UNITED STATES ENVIRONMENTAL PROTECTION AGENCY  
REGION 10  
1200 Sixth Avenue, Suite 900  
Seattle, Washington 98101-3140

**MEMORANDUM**

**SUBJECT:** Review of the OIG Hotline Report, Contaminated Soil Waste Repository at East Mission Flats, Idaho, June 8, 2009 and Appendix G and Q of the 90% Design Report

Figure 14. Water Elevation and Coeur d'Alene River Flowrate

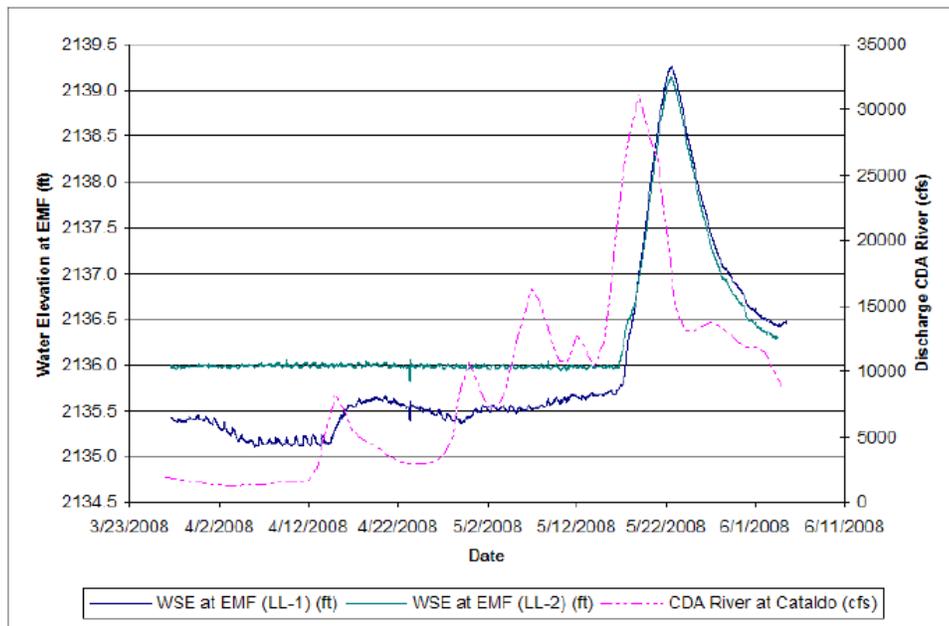
- 10% and 50% reduction in  $K$  using the results from a field test at the repository.
- The starting groundwater elevation in MW-C was taken from the previous measurement in February 2008, 2127.60 feet.
- The duration of a significant head or standing water was based on a hydrograph near the repository location (Cataldo station). This duration was 20 days. See the following page taken from 90% Design Report, Figure 14

Figure 14 was taken from the East Mission Flats 90% Design Report, June 2009. This is a hydrograph of the Coeur d'Alene (CDA) River near Cataldo, Idaho. This hydrograph is illustrating the dates (time versus discharge) and the discharge in cubic feet per second (CFS) with the elevation or stage height of the river. The event in question started on May 20, with a maximum discharge rate over 30,000 CFS. The elevation height, 2,136 feet was chosen for a base flow because it is an approximate elevation of the ground surface and also the beginning of the largest discharge event on the CDA River at the Cataldo station. On approximately June 8<sup>th</sup> the hydrograph returned to the base flow elevation of 2,136 feet. The duration period was 20 days. The other two hydrographs on figure 14 were measurements of the surface water elevation taken from data logger at the EMF site. To be conservative, the hydrograph from the Cataldo

station was chosen it added longer time duration but the three hydrographs are similar. If LL-1 or LL-2 were used the groundwater elevation would have been less due to the shorter time duration.
